October 8, 1984  
ST-HL-AE-1136  
File Number: G12.23

South Texas Project  
Units 1 & 2  
Docket Nos. STN 50-498, STN 50-499  
Supplemental Information on the Safety Injection  
System Piping Deficiency

SAFETY INJECTION  
SYSTEM SUCTION LINE  
ALTERNATIVE DESIGN

Figure 1

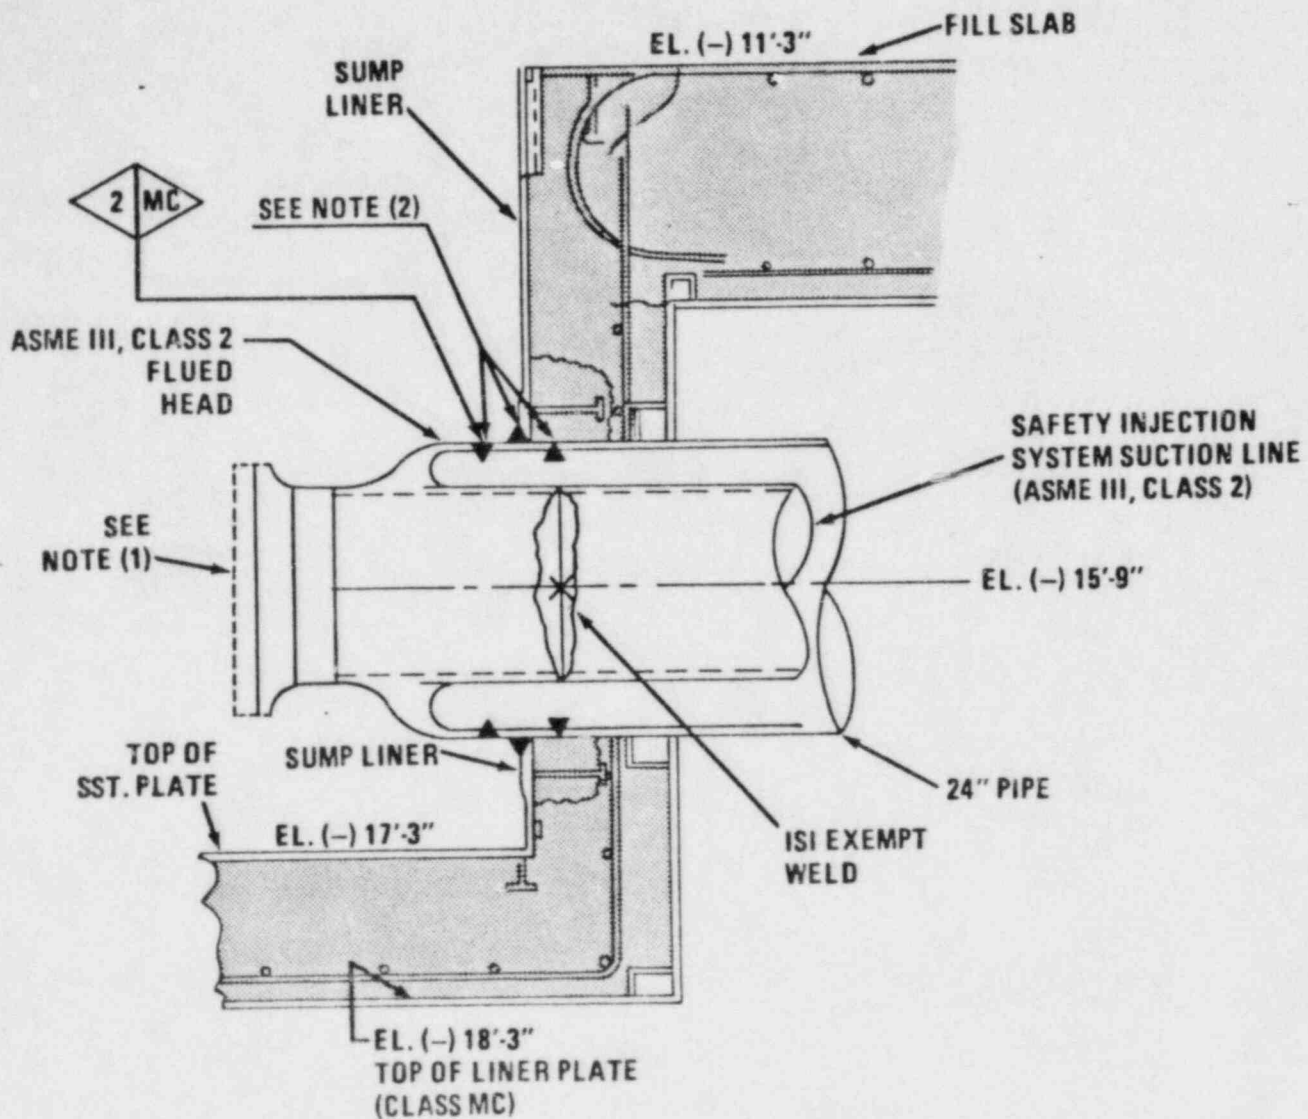
Bechtel has finished their evaluation and has modified the design. Figure 1 shows the revised design which will be used on the South Texas Project (STP). This revised design has been incorporated on the STP.

- NOTE (1): BLIND FLANGE USED FOR INTEGRATED LEAK RATE TESTING
- NOTE (2): THE WELD SHALL COMPLY WITH REQUIREMENTS OF ASME SECTION III, DIV. 1, SUBSECTION NE-4430 AND NE-5262

**Figure 2**

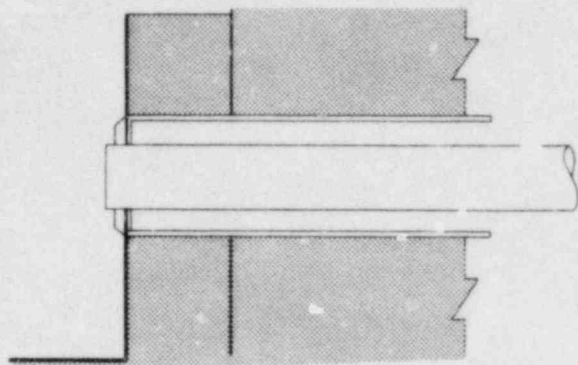
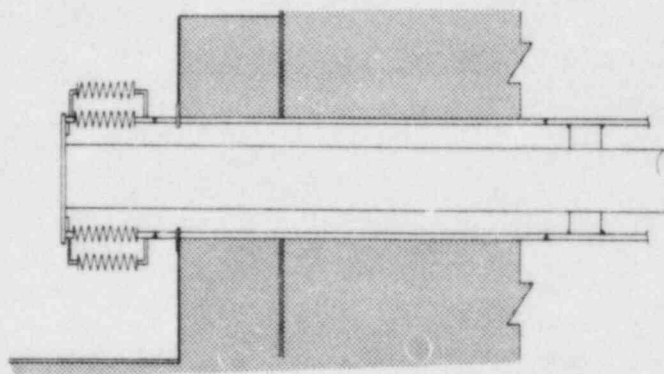
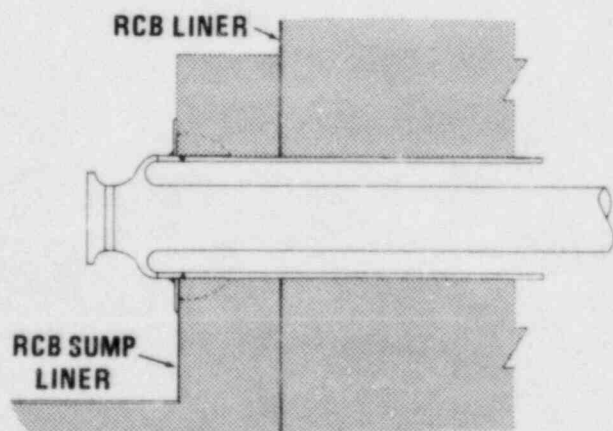
Instead of an expansion joint inside containment, the revised design features a flued head inside containment and eliminates the guard pipe, and anchor outside containment. Figure 2 shows a comparison of the previous designs with the current design.
